PROJECT INFORMATION		DOCUMENTS FOR REVIEW AND FILES LOCATION		TIME LINES
Proj. Name and Number:	Arlington STP BP17(2)	PLANS	FILE LOCATION : Z:\Highways\MUN\LCL\LTF Projects\Arlington STP BP17(2)\3 Conceptual\Plans\Arlington STP BP17(2) Concept Plans 083018	SUBMITTED: 09-07-2018
EA No.: BP17002	PPMS: 17F243	ESTIMATE	FILE LOCATION : Z:\Highways\MUN\LCL\LTF Projects\Arlington STP BP17(2)\3 Conceptual\Documents\Conceptual Estimate\Arlington STP BP17(2) Conceptual Cost Estimate	
Project Manager: Jon Kaplan			FILE LOCATION :	
Program: Municipal Assistance	Phase: Conceptual		FILE LOCATION :	DEADLINE: 09-28-2018
District: District 1	If Multiple Districts Specify		FILE LOCATION :	COMPLETED: 10-02-2018
Traffic Signal: Yes			FILE LOCATION :

PLANS FOR CONSTRUCTION OF RECREATION PARK PEDESTRIAN ACCESS ARLINGTON, BENNINGTON COUNTY, VERMONT

ARLINGTON STP BP17(12)

### TYPICAL CONCRETE WALK PLAN DETAIL

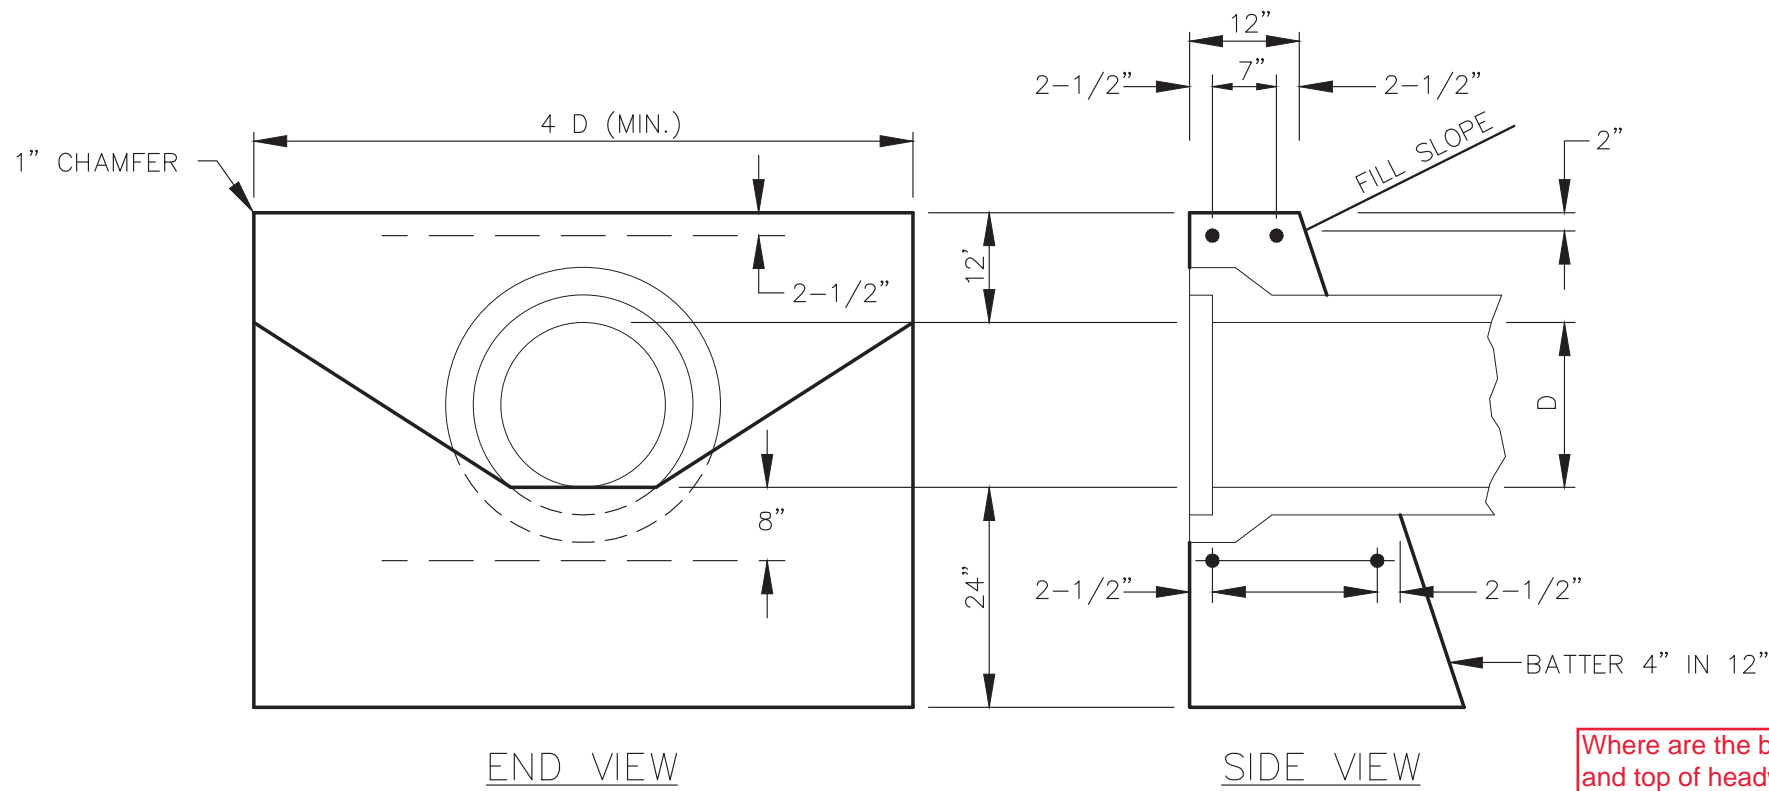
Why is there mesh?

TRAFFIC CONTROL PLAN

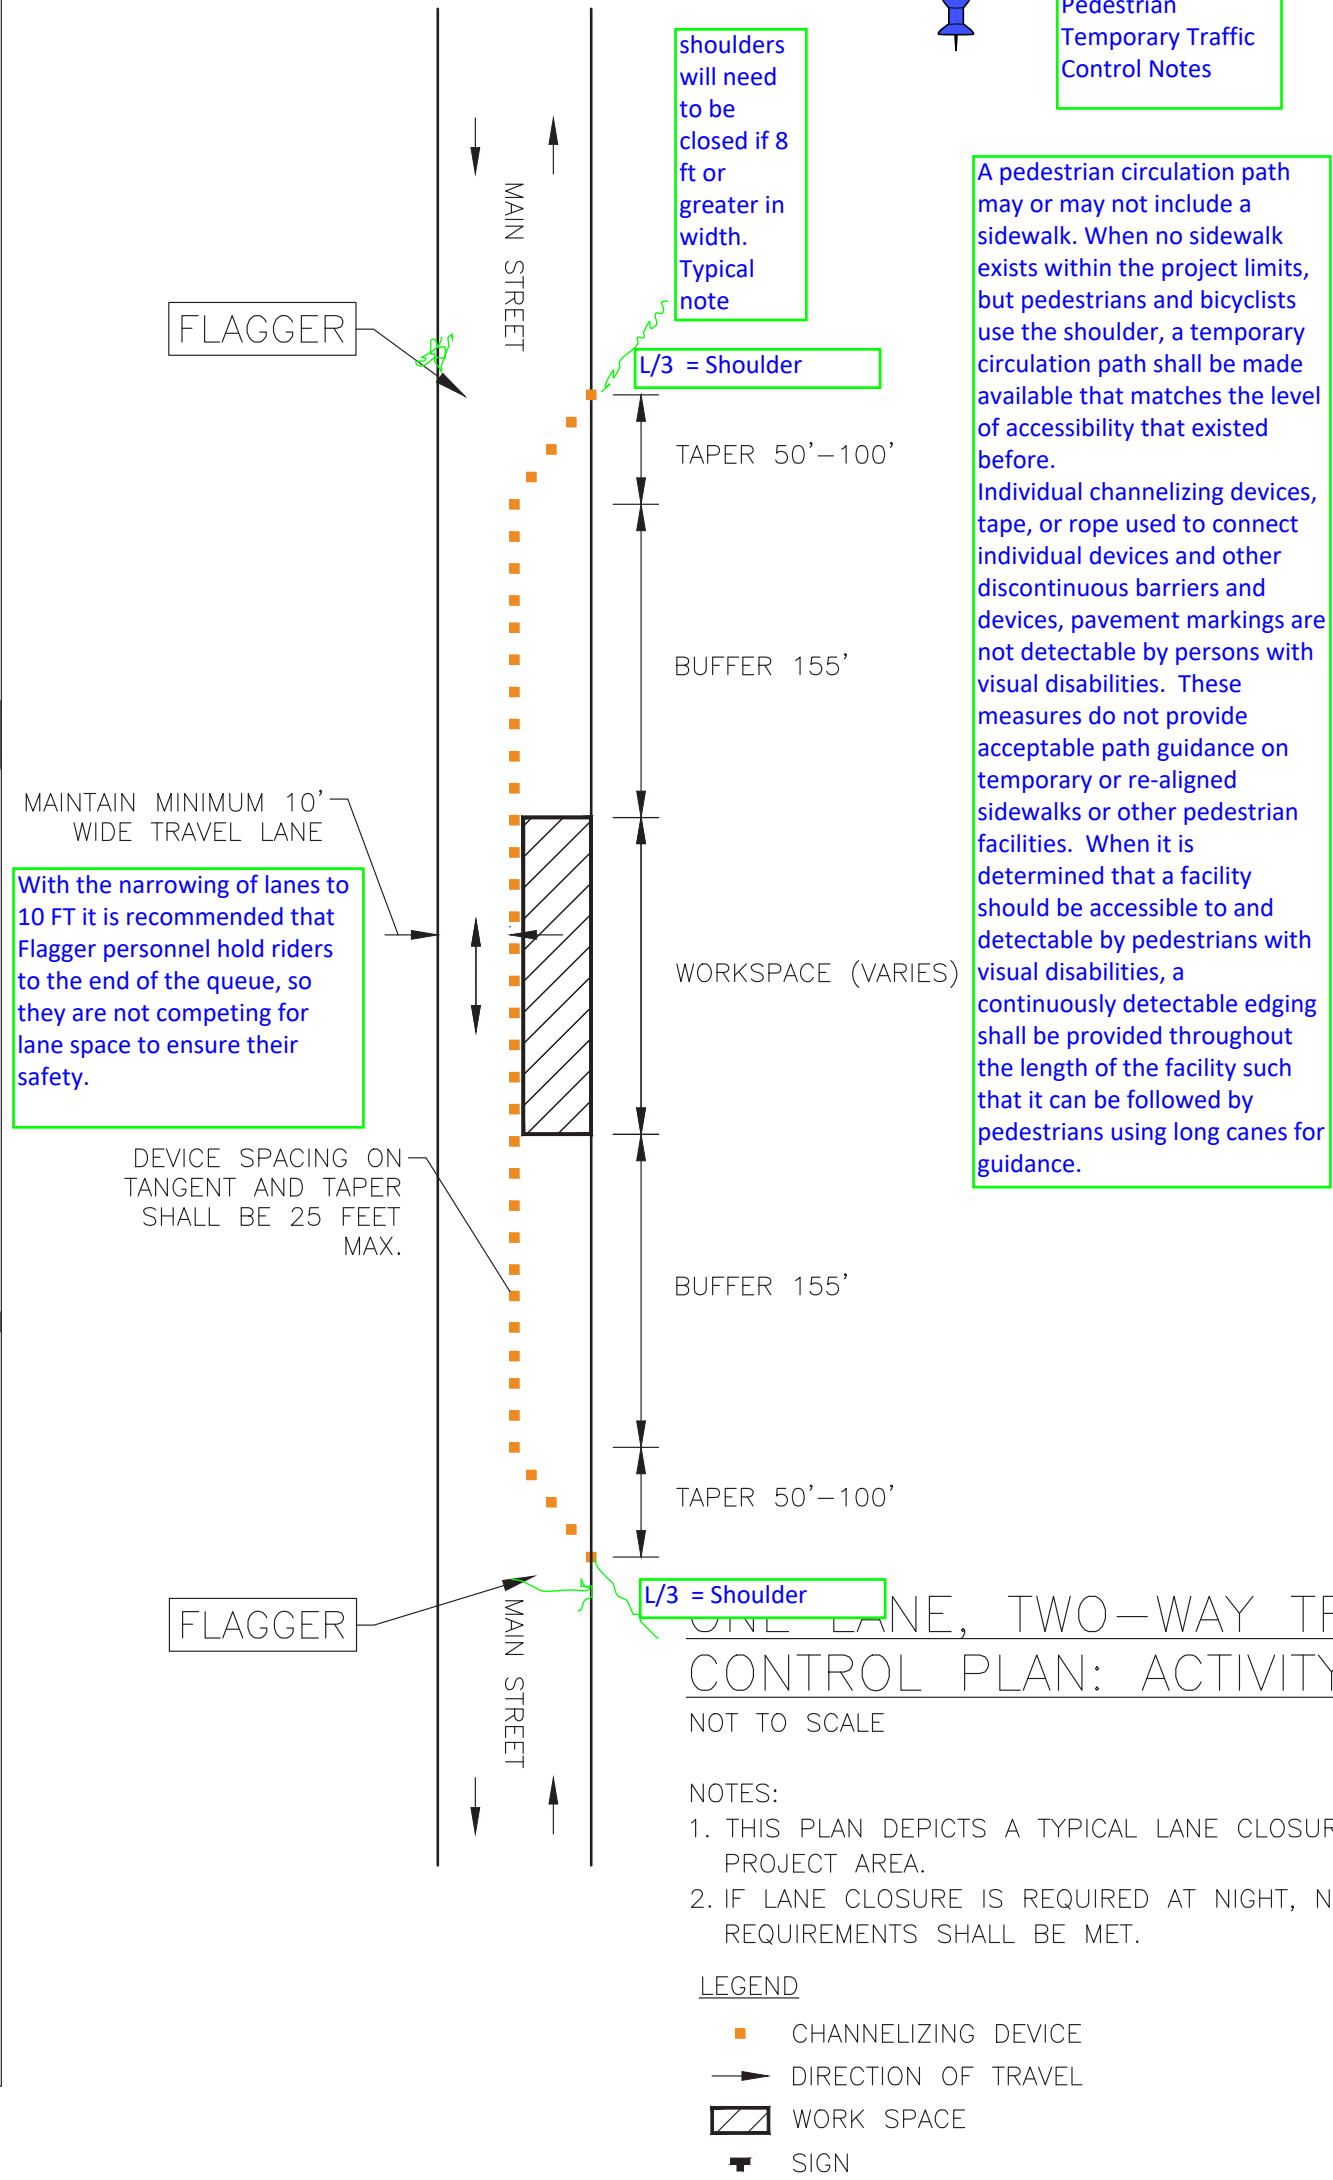
- CONSTRUCTION SIGNS SHALL BE IN NEW OR LIKE-NEW CONDITION ~~PER VTRANS STANDARD~~ **such as?**
- ALL CONSTRUCTION SIGNS SHALL BE 48" BY 48", WHICH THE EXCEPTION OF G20-2A SIGNS WHICH SHALL BE 48" BY 24". SIGNS SHALL BE BLACK LETTERING ON FLUORESCENT ORANGE BACKGROUND.

- PAYMENT FOR THE INSTALLATION, MAINTENANCE, AND REMOVAL OF ALL CONSTRUCTION SIGNING WILL BE MADE UNDER 941.10 ~~TRAFFIC CONTROL~~ **641.11?**
- THE CONTRACTOR SHALL COVER OR REMOVE ANY SIGNS THAT CONTRADICT TEMPORARY TRAFFIC CONTROL SIGNS. ALL SIGNS REMOVED OR COVERED BY THE CONTRACTOR SHALL BE REPLACED OR UNCOVERED BY THE CONTRACTOR WHEN THIS TRAFFIC CONTROL PLAN IS DISASSEMBLED. PAYMENT FOR THIS WORK SHALL BE ~~CONSIDERED INCIDENTAL TO 641.10 TRAFFIC CONTROL~~ **641.11?**

- LANE CLOSURES MAY BE REQUIRED THROUGHOUT CONSTRUCTION. ALL LANE CLOSURES SHALL BE COORDINATED WITH THE VILLAGE HIGHWAY FOREMAN **State highway, so should this be the District?** A MINIMUM OF 48 HOURS PRIOR TO THE CLOSURE.

Bicyclist should not be forced to dismount;  
Cyclist should not be diverted to the opposite side of the roadway  
The management of temporary facilities should be given sufficient attention. It is important that cyclist's routes are free of ruts, sand and mud to prevent cyclist's crashes.  
Per the VTrans Bicycle Corridor Priority Map that VT 7A in Arlington is considered a high use/priority route.
